# Access Compliance Report

## Public Rights-of-Way

| Intersection ID: 16578                  | Main Street: CONWAY_AV | Cross Street: SCALEYBARK_RD             | Location: E            |
| ADA ID: A95D6AD1CAFB                    | Ramp Type: BlendTrans2 | Initial Pass/Fail: Pass                 | Overall Compliance: No |

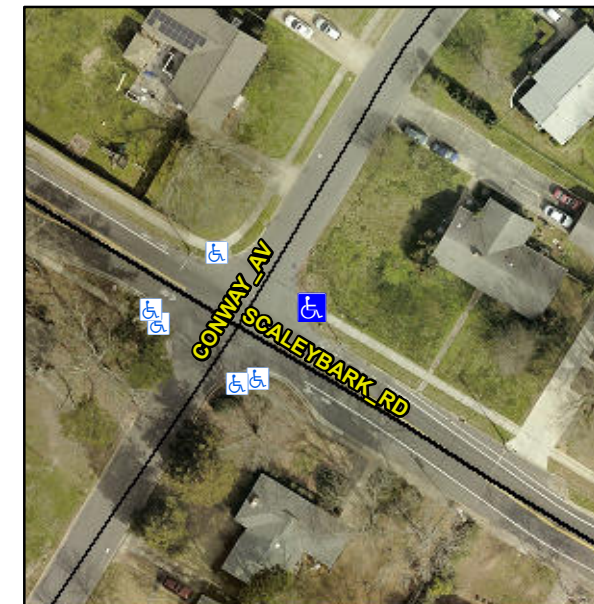
**R304.5.3, R305.1.4, R305.2**

| Compliance | Description           | Data  | Compliance | Description                 | Data  |
|------------|-----------------------|-------|------------|-----------------------------|-------|
| Yes        | Ramp Width (in)       | 105.0 | No         | BlendTrans XSlope (%)       | 2.4   |
| N/A        | Landing X Slope (%)   | N/A   | No         | DWS Full Width?             | No    |
| Yes        | Gutter Lip Ht (in)    | 0.0   | No         | Gutter X Slope (%)          | 3.1   |

**Remove & Replace Curb Ramp With Two New Directional Ramps or Equivalent. Remove & Replace Gutter.**
